**RE: Soil Vapor Survey- Work Plan Addendum  
BP Service Station No. 11270  
3255 Mecartney Road  
Alameda, California  
Fuel Leak Case No. RO0000511**

**Attachment A**

Subject: Work Plan Addendum for Fuel Leak Case No. RO0000511 and GeoTracker Global ID  
T0600101198, BP #11270, 3255 Mecartney Road, Alameda, CA 94501

FIGURE 2  
 SITE PLAN WITH PROPOSED  
 SOIL VAPOR LOCATIONS  
 BP STATION NO. 11270  
 3255 MECARTNEY ROAD  
 ALAMEDA, CALIFORNIA

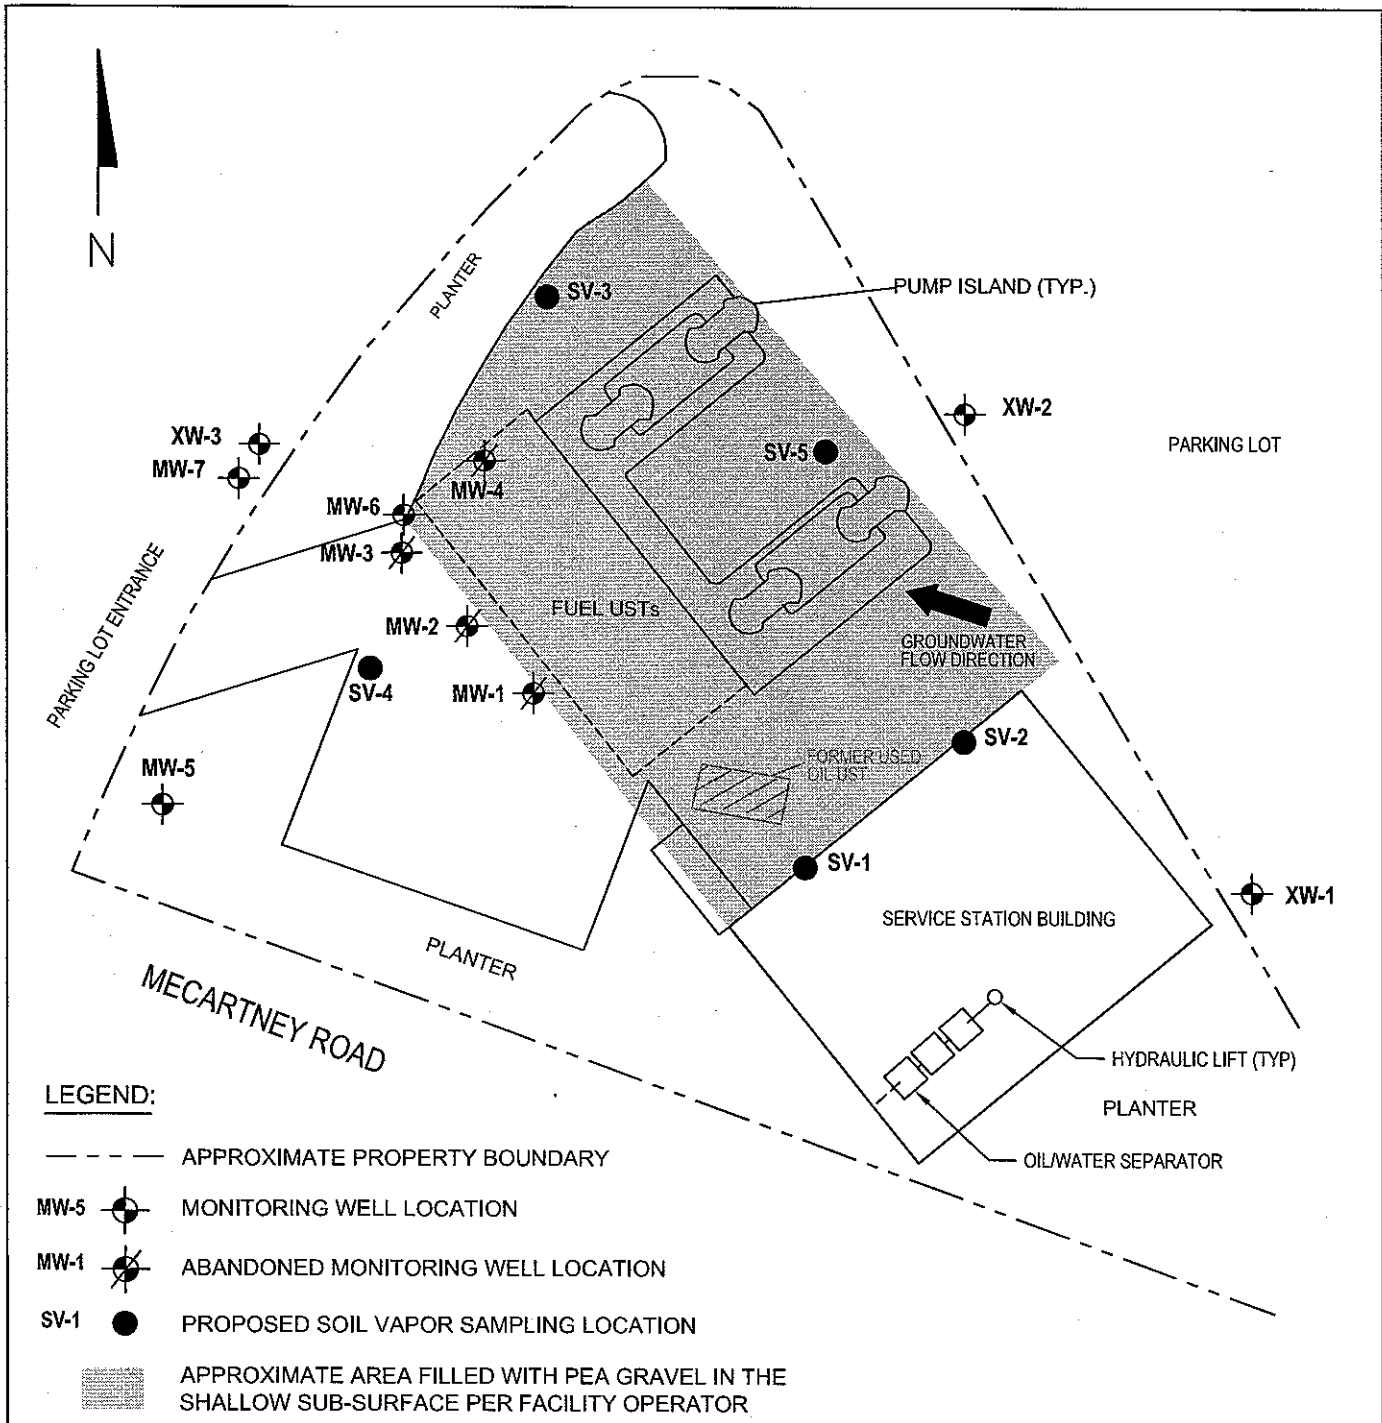
**1. Sampling Density:** TPH-G and benzene at the site were detected as high as 2,000 mg/kg and 18 mg/kg, respectively in the location of the former fuel USTs. The June 2008 work plan proposed two soil vapor sampling points to evaluate potential contaminant volatilization in the vicinity of the service station building. ACHCSA recommends additional soil vapor sampling points to more adequately characterize the site.

1. **Sampling Density** – As stated in our May 8, 2009 correspondence, concentrations of TPH-g and benzene at the site were detected as high as 2,000 mg/kg and 18 mg/kg, respectively, located in the vicinity of the former fuel USTs. Delta proposes to install two soil vapor sampling points near the service station building, approximately 45 feet southeast of the elevated residual hydrocarbons detected in soil. Although the proposed sampling locations appear to evaluate potential contaminant volatilization to indoor in the vicinity of the service station building, the proposed locations do not appear to evaluate the "hot spot" at the site. Also, it is important to note that case closure for the site is based on not only the current land use scenario, but future land use as well. Therefore, it is conceivable that a commercial

structure could be constructed over areas of elevated residual hydrocarbons at the site, which were not adequately characterized. To adequately characterize the site, additional sampling locations in the areas of likely impact are necessary. Please propose a scope of work to address the above-mentioned concerns and submit a work plan addendum due by the date specified below.

In addition to the previously mentioned soil vapor points in the June 2009 work plan, Delta recommends three soil vapor points (SV-3 through SV-5), shown on **Figure 2**. Based on the August 1992 site assessment product sheen was observed in the purge groundwater from each of the former monitoring wells MW-1 through MW-4. Therefore, Delta recommends a soil vapor point (SV-4) be installed in the vicinity of former monitoring wells MW-1 and MW-2.

To fully characterize the site in the vicinity of the fuel islands, soil vapor point SV-5 should be installed. In addition, based on the groundwater flow direction and to determine the potential of off-site migration, soil vapor point SV-3 should also be installed. Groundwater samples previously collected from boring TB-1, as referenced in the June 8, 2009 work plan, which is in the vicinity of proposed soil vapor point SV-3 contained TPH-G at concentrations of 1,500 parts per billion (ppb).

FIGURE 3  
 WELL CONSTRUCTION DETAIL  
 SV-1 THROUGH SV-5  
 BP STATION NO. 11270  
 3255 MECARTNEY ROAD  
 ALAMEDA, CALIFORNIA

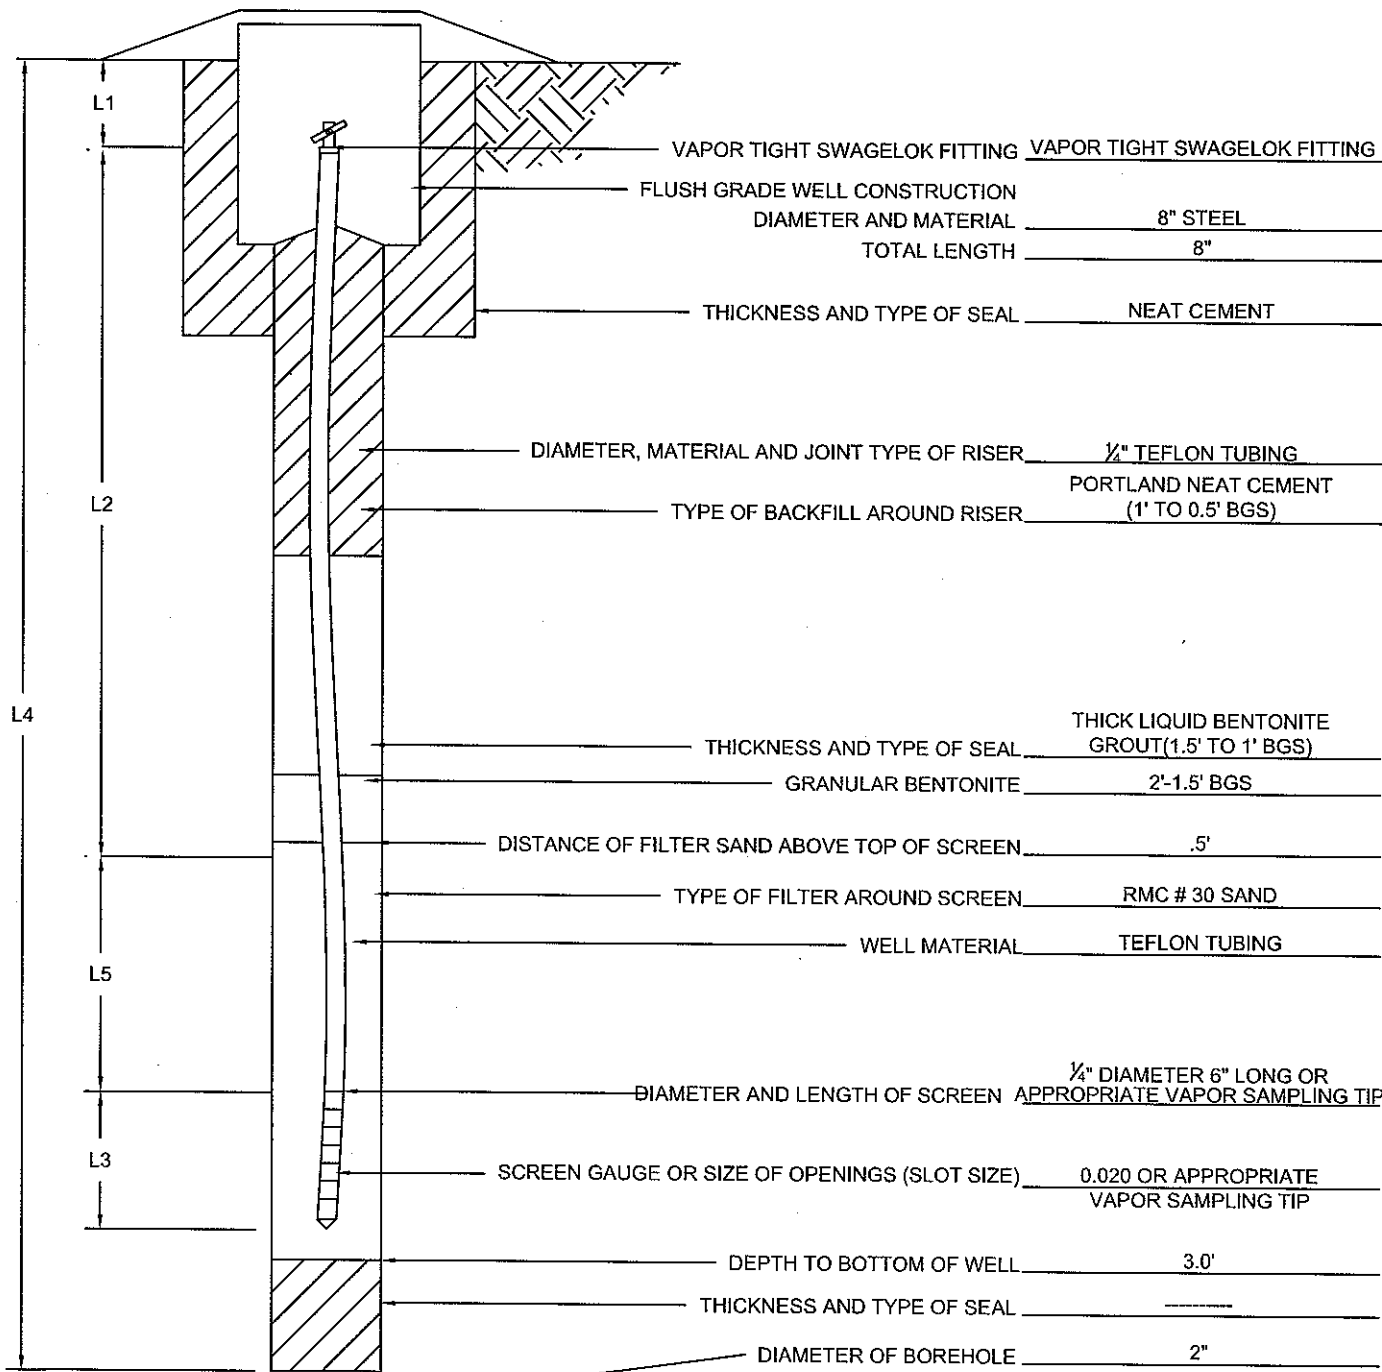
**2. Soil Vapor Sampling Point Methodology:** ACHCSA is concerned that installing a sampling tip using direct push technology may push hydrated bentonite into the sand effectively sealing off accumulated soil vapor which is being sampled. ACHCSA recommends an alternative method be conducted by installation of appropriate tubing into the borehole during construction and subsequently collect a soil vapor sample through the pre-installed tubing.

2. **Soil Vapor Sampling Point Methodology** – Delta states that “[s]oil vapor sampling points will be hand augered to five (5) feet bgs for utility clearance. The borehole will be backfilled as follows: sand from 3.5 to five (5) feet bgs, hydrated bentonite granules from 3.5 to 2.5 feet bgs, thick bentonite mixture from just below existing asphalt to 2.5 feet bgs, and thin layer of cold patch asphalt to grade.” Following the two week stabilization period, Delta states that “[a] boring will be advanced, using direct push technology, to place a soil vapor sampling tip into the previously installed sand zone (approximately 3.5 to five feet bgs).” ACEH is concerned that installing a sampling tip using direct push technology may push hydrated bentonite into the sand effectively sealing off accumulated soil vapor, which we are attempting to sample. It may be advantageous to install appropriate tubing into the bore hole during construction and subsequently collect a soil vapor sample through the pre-installed tubing. Please propose a scope of work to address the above-mentioned concerns and submit a work plan addendum due by the date specified below.

The temporary vapor sampling points will be excavated using a two-inch diameter hand auger to a depth of five (5) feet bgs. Delta personnel will place an appropriate length, based on the depth of the hole of ¼-inch Teflon tubing into the auger hole. This tubing will be screened at the down-hole end with an appropriate vapor sampling tip. A vapor tight Swagelock® valve will be placed on the other end of the tubing. A sand pack composed of #30 sand will be placed from the bottom of the hole to approximately 6 inches above the top of the screen (5 to 4 feet bgs). Bentonite chips will be installed above the sand pack from 4 to 3 feet bgs, and thick bentonite grout will be placed between 3 feet and 1 foot bgs in the temporary vapor sampling point. A surface seal of concrete will seal the hole from 1 foot to .5 feet bgs to the surface, which will be completed with an 8-inch diameter traffic rated vault box concreted in place. A construction diagram for the temporary vapor sampling points is included at **Figure 3**.

FIGURE 4  
SAMPLING FLOW DIAGRAM

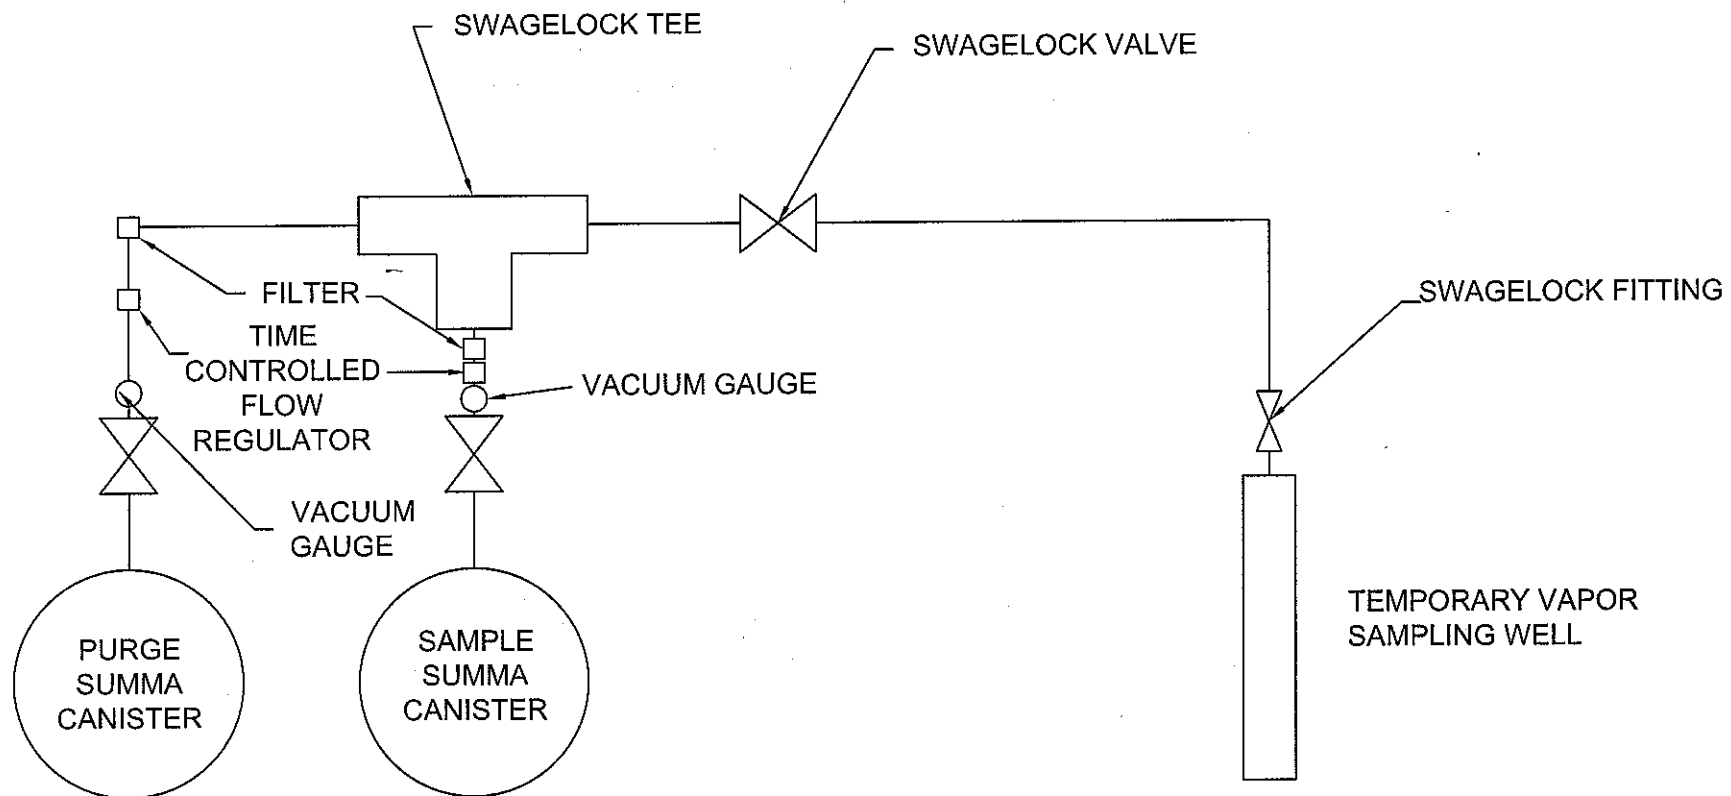
**3. Tracer Compound:** In the June 2009 work plan the tracer compound used to evaluate potential ambient air intrusion for leak check purposes was not identified. The work plan also did not identify how the tracer would be applied. ACHCSA recommends that soil vapor wells or probes be constructed with the sampling device and all fittings placed under a shroud with pliable weather stripping along its base to maintain a tracer gas around all sampling connections.

3. **Tracer Compound** – Delta states that a tracer compound will be analyzed to evaluate potential ambient air intrusion for leak check purposes. However, Delta does not identify the tracer compound. Delta does not identify how the tracer will be applied or whether the tracer is a gas or liquid compound. It is recommended that soil vapor wells or probes are constructed with the sampling device and all fittings placed under a shroud with pliable weather-stripping along its base to maintain a tracer gas atmosphere. The shroud should ensure that there is sufficient tracer gas around all sampling connections. The shroud should have a port for inserting a monitoring and sampling device (e.g. Photo Ionization Detector) to ensure that tracer gas atmosphere is maintained. Please propose a scope of work to address the above-mentioned concerns and submit a work plan addendum due by the date specified below.

milliliters/minute, and a Swagelock® vapor tight valve. Swagelock® type fittings will be used for all connections. The process flow diagram of the sampling set up is shown on **Figure 4**.

Delta personnel will apply an isopropyl alcohol leak tracer every five minutes during sampling. Paper towels or gauze saturated with isopropyl alcohol will be placed on the top of the well casing to Teflon® tubing joint and the vapor tight valve down-hole connection.
